1 August 2018
EIR Reference: E0003795

**INTRODUCTION OF CLASS D CONTROLLED AIRSPACE IN THE VICINITY OF
BRISTOL AND CARDIFF INTERNATIONAL AIRPORTS**

BRISTOL AND CARDIFF AIRSPACE CHANGE PROPOSAL - ENVIRONMENTAL FACTORS

Airspace Change Proposal Case Study Report

FIGURE 14 Average heights of aircraft passing through each gate

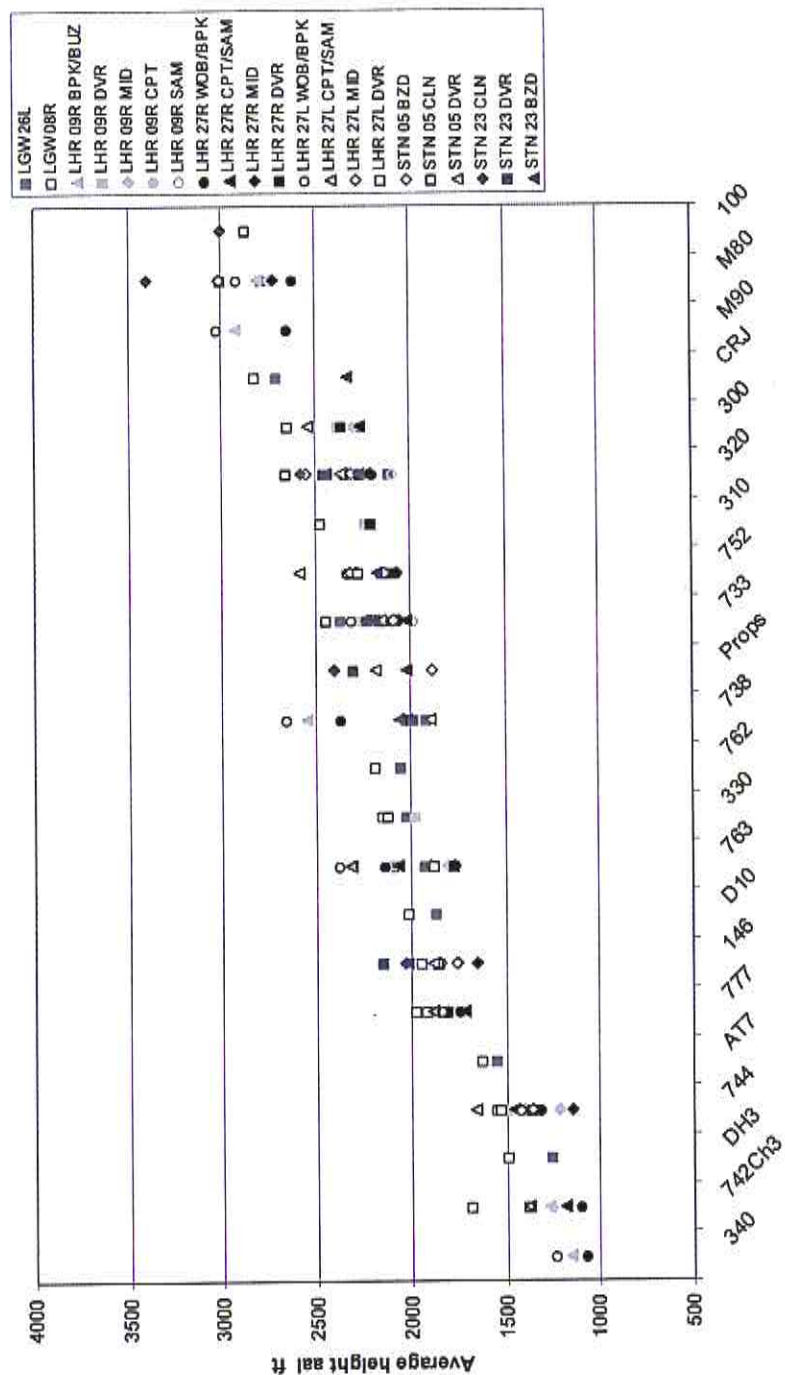
24. It is accepted that climb gradients will vary dependent on circumstances and this can be seen by the variation of climb gradients by routes shown in Figure 14 to ERCD Report 0207. However, the sponsor has not provided evidence to demonstrate that climb gradients at Bristol are significantly different from data collected during the course of production of ERCD Report 0207. The sponsor's assertions about climb gradients and noise levels cannot be accepted without supporting evidence.
